Access Compliance Report Public Rights-of-Way (Curb Ramps)

Main Street: JARANO_ST Cross Street: OCASO_ST Location: N

ADA ID: RPRK211124141845 Ramp Type: Type 1 - Perpendicular Initial Pass/Fail: Fail Overall Compliance: No Severity Score: 15

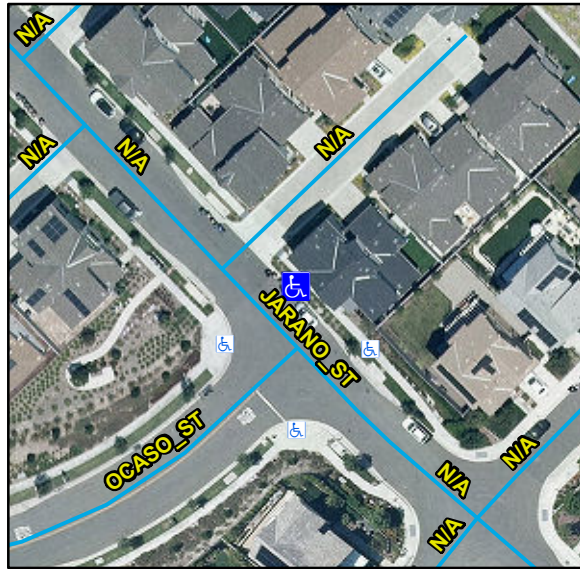
Compliance	Description	Data	Compliance	Description	Data
N/A	Ramp Length (in)	71	N/A	Flare Type LT	
Yes	Ramp Width (in)	60			N/A
No	Ramp Run Slope (%)	10.7	N/A	Flare Slope LT (%)	N/A
Yes	Ramp Cross Slope (%)	0.5	N/A	Flare Traversable LT	N/A
N/A	Landing Present	N/A	N/A	Flare Type RT	
N/A	Landing Length (in)	N/A			N/A
N/A	Landing Width (in)	N/A	N/A	Flare Slope RT (%)	N/A
N/A	Landing Run Slope (%)	N/A	N/A	Flare Traversable RT	N/A
N/A	Landing Cross Slope (%)	N/A	N/A	DWS Provided	N/A
N/A	Landing Movement Obstructed?	N/A	N/A	DWS Contrast	N/A
	Landing Movement Type	N/A	N/A	DWS Length (in)	N/A
N/A	Landing Shared	N/A	N/A	DWS Full Width	N/A
N/A	Clear Space	N/A	N/A	DWS Offset Left (in)	N/A
N/A	Clear Space To Crosswalk (in)	N/A	N/A	DWS Offset Right (in)	N/A
N/A	Marked Crosswalk 1	No	N/A	Marked Crosswalk 2	N/A
	Crossing 1 Direction	SW		Crossing 2 Direction	N/A
	Marked Crosswalk 1 Width (in)	N/A		Marked Crosswalk 2 Width (in)	N/A

N/A	Ramp Inside Crosswalk 1	N/A	Yes	Ramp Inside Crosswalk 2	N/A
	Crossing 1 Slope (%)	2.2		Crossing 2 Slope (%)	N/A
	Crossing 1 Cross Slope (%)	2.4		Crossing 2 Cross Slope (%)	N/A
N/A	Gutter Ponding	N/A	No	Curb Slope	11.5
Yes	Gutter Lip Height (in)	0		Road Run Slope (%)	N/A
N/A	Gutter Run Slope (%)	N/A		Road Cross Slope (%)	N/A
N/A	Gutter Cross Slope (%)	N/A			
Yes	Overall Surface Condition: Acceptable		Yes	Perp Joint Present	Yes
	Cross Gutter Present?	No		Spandrel Present?	No
	Replace Cross Gutter?	N/A		Replace Spandrel?	N/A

Possible Solutions:

Remove & Replace Entire Ramp.
